WASTE MANAGEMENT LANDFILL: REVIEW OF FURTHER WORK COMPLETED BY TONKIN + TAYLOR AS REQUESTED BY THE ENVIRONMENT COURT

2.0 Tonkin & Taylor Technical Memorandum dated 9 February 2024 Review

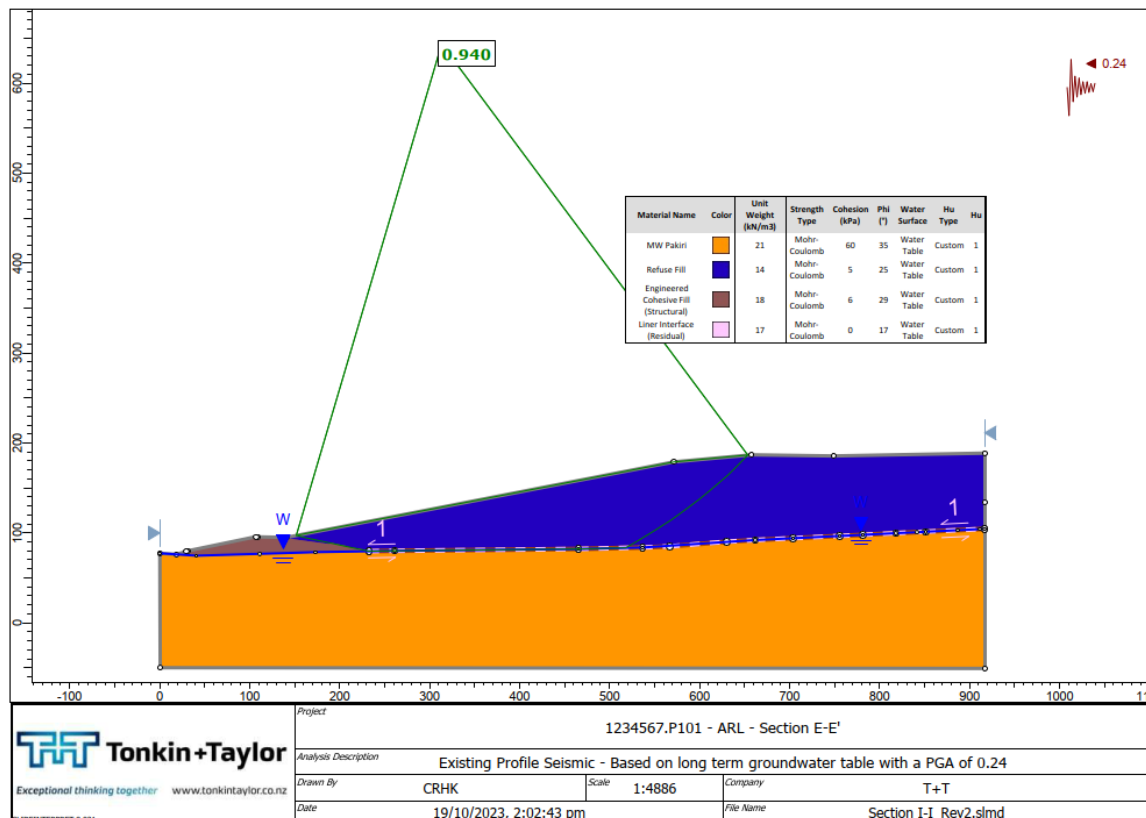
1. The Tonkin & Taylor memo dated 9 February 2024 utilises the design factor of safety (FoS) as outlined in the now superseded NZGS Slope Stability Geotechnical Guidance Series - Unit 1 General Guidance - Draft for Comment (Part 7 Slope Stability Modelling, Table 7.1). The current December 2024 issue of the aforementioned document and Table 7.1 referred to by T+T has been modified with the design FoS values removed. Please provide evidence that the requirements of the current NZGS Slope Stability Geotechnical Guidance documents (December 2024) have been adopted into the slope stability assessments.

T+T response by Tim Coote (T+T) - *Given there is no waste industry specific guidance for landfill design Factor of Safety thresholds, the minimum design factors of safety thresholds were selected based on general industry accepted criteria (including Part 7 Slope Stability Modelling, Table 7.1 as a typical geotechnical industry guideline that, in turn, refers to other reference sources such as NZTA Bridge Manual 2022, NZ Dam Safety Guidelines, U.S. Army Corps etc.) and to be consistent with those typically adopted at landfills in New Zealand, including Kate Valley Landfill. We maintain these thresholds continue to be relevant today irrespective of the latest version of the reference geotechnical guidelines (which were issued after the memorandum was prepared) having chosen to remove them.*
